MISSOULA COUNTY
INVITATION FOR BID ADDENDUM

IFB NAME: Missoula County 311 Woody St. Remodel
DUE DATE: October 8th, 2026 @ 4:00pm., Local time

ADDENDUM NUMBER: 1 **09-2026-03-A**

Attached are written questions received in response to the IFB. These questions, along with the County's responses, become an official amendment to this IFB.

1 ELECTRICAL FIRST FLOOR DEMO PLAN
SCALE: 1/4" = 1'-0"

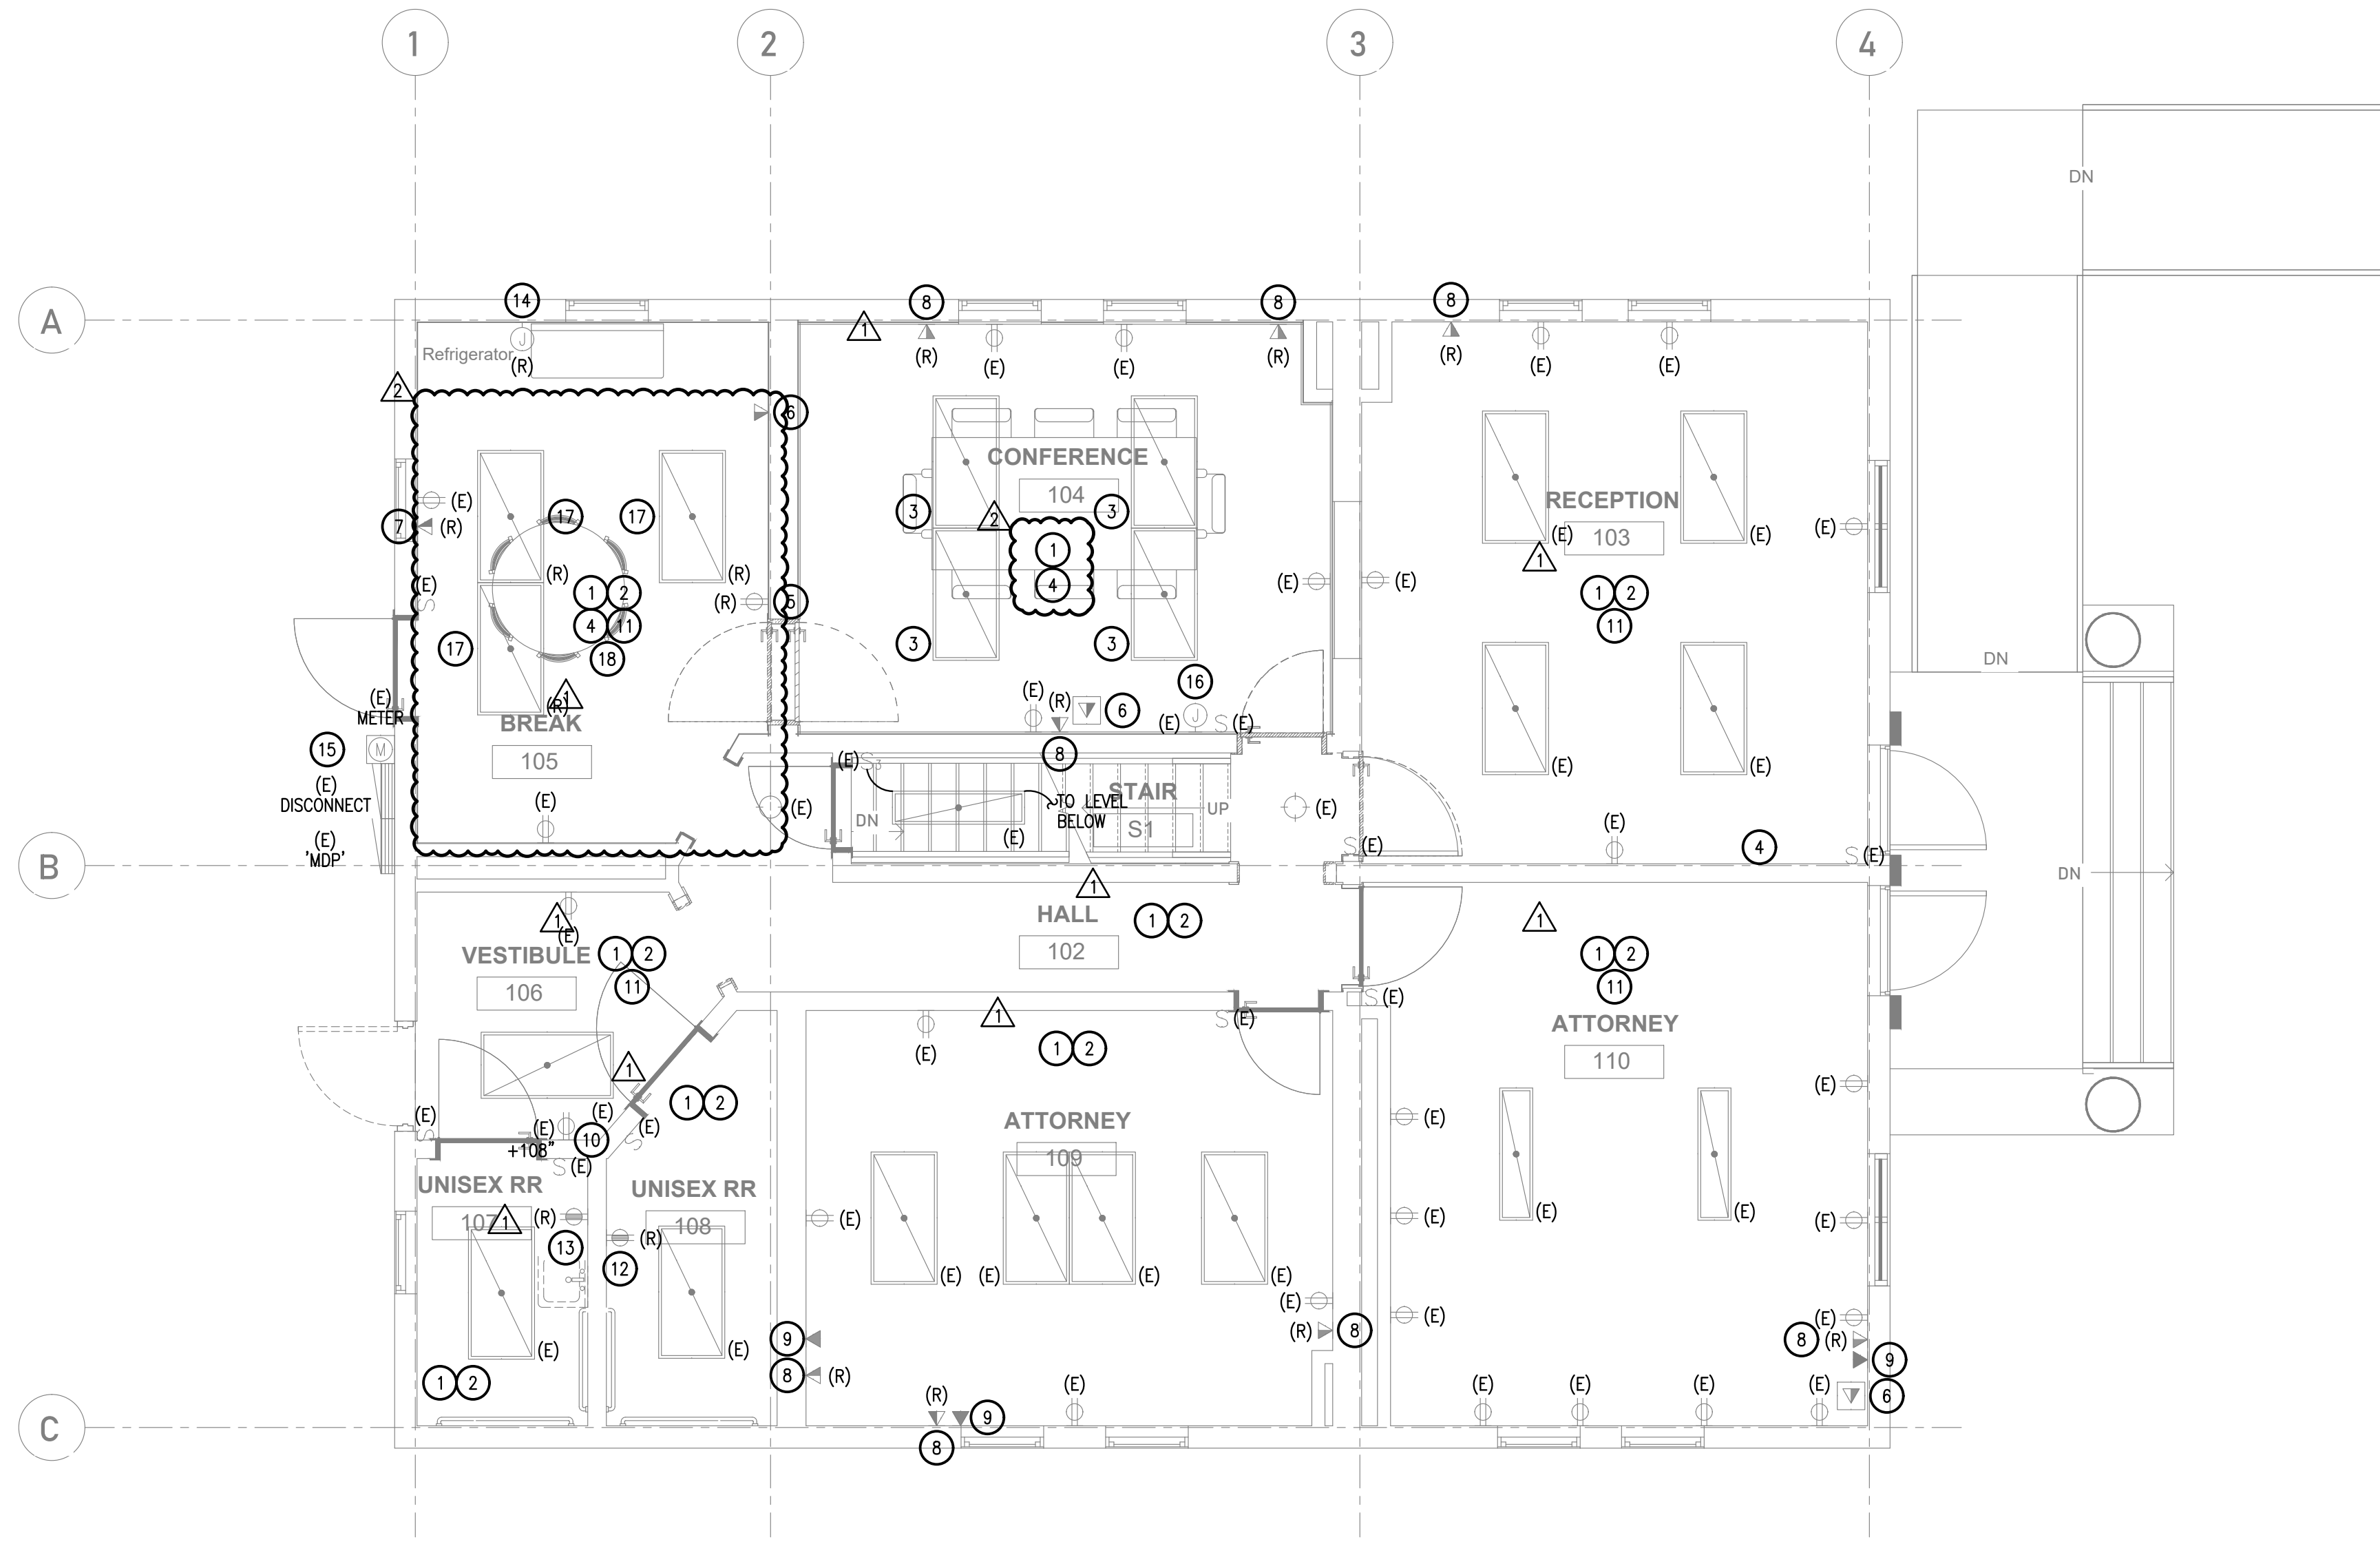
12. **Heat Detectors:** The additional ceiling mounted heat detectors have been marked to be demolished. Refer to sheet: E2.1D:

13. Lights in room 105 are to be removed and reinstalled. Clarifying notes have been added to sheet E2.1D.

14. **Rooms 105 and 104 electrical devices:** Electrical devices in rooms 105 and 104 to be removed and protected for reinstallation. Refer to sheet AD2.11 and E2.1D.

1 ELECTRICAL SECOND FLOOR DEMO PLAN
SCALE: 1/4" = 1'-0"

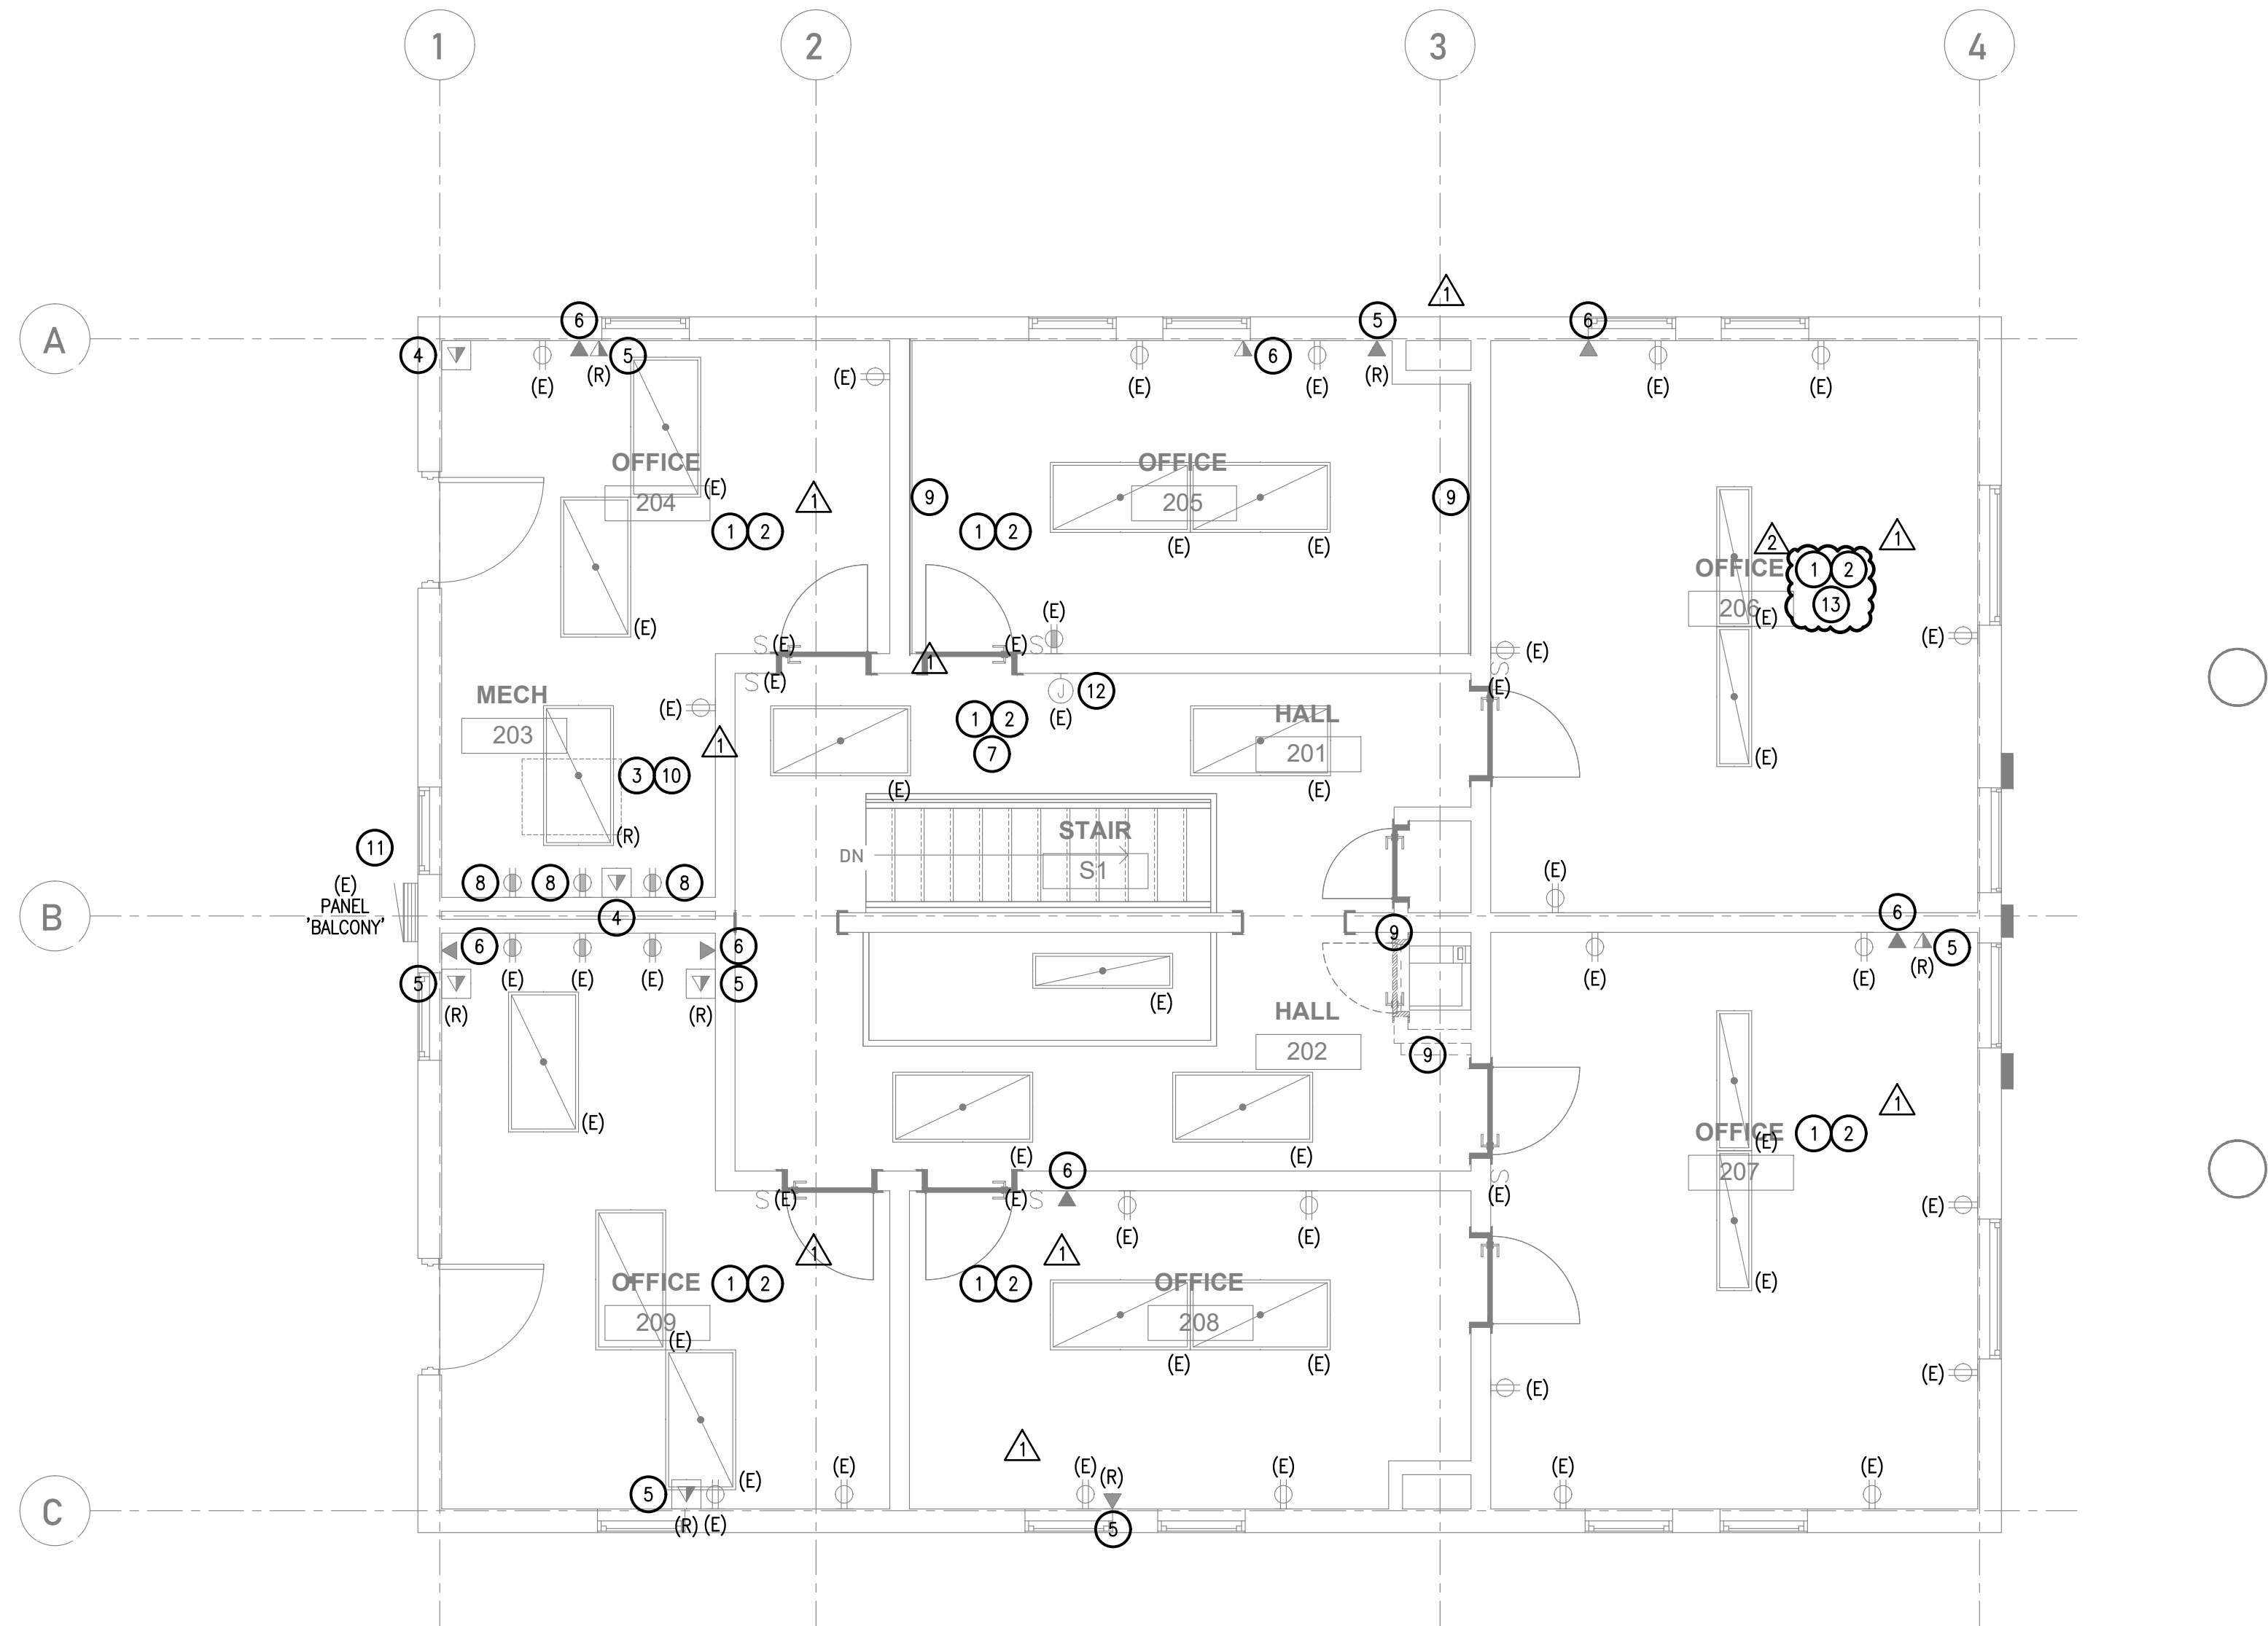
15. **2nd Floor thermostat:** Locate per sheet M1.1. Conflicting location on E2.2D has been corrected.

1 ELECTRICAL ROOF PLAN

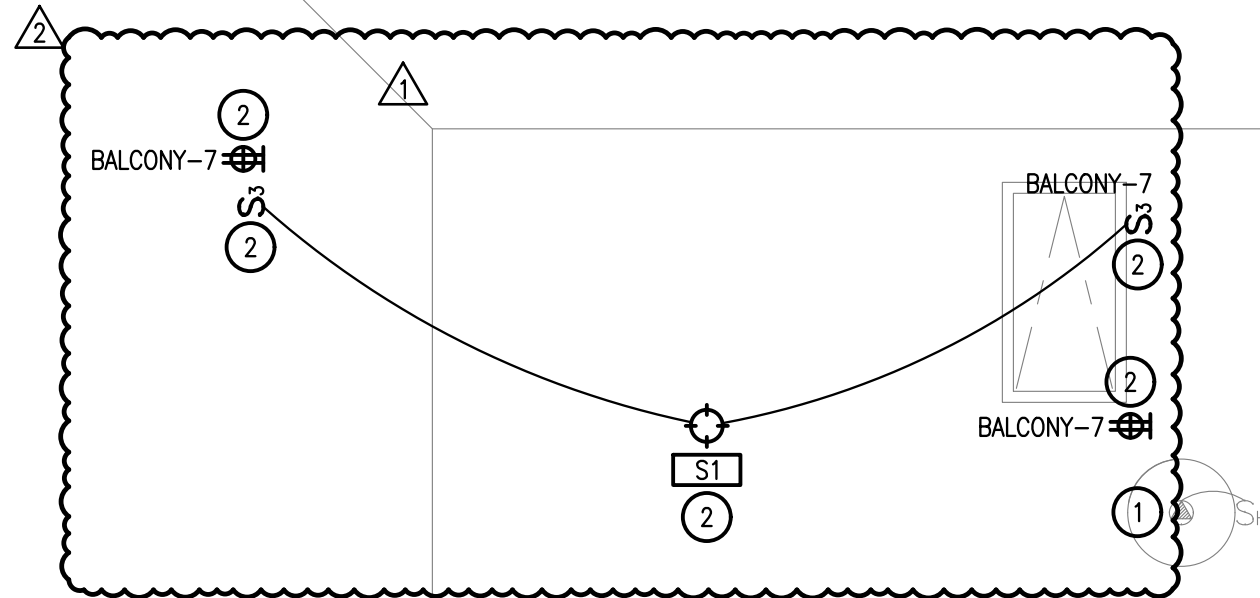
Question #2: During the walkthrough, they mentioned new lights going into the attic area and a new receptacle however they do not have any shown on the drawings. Are we anticipating an addendum that will be adding this work?

See revised sheet E2.3, for added attic scope
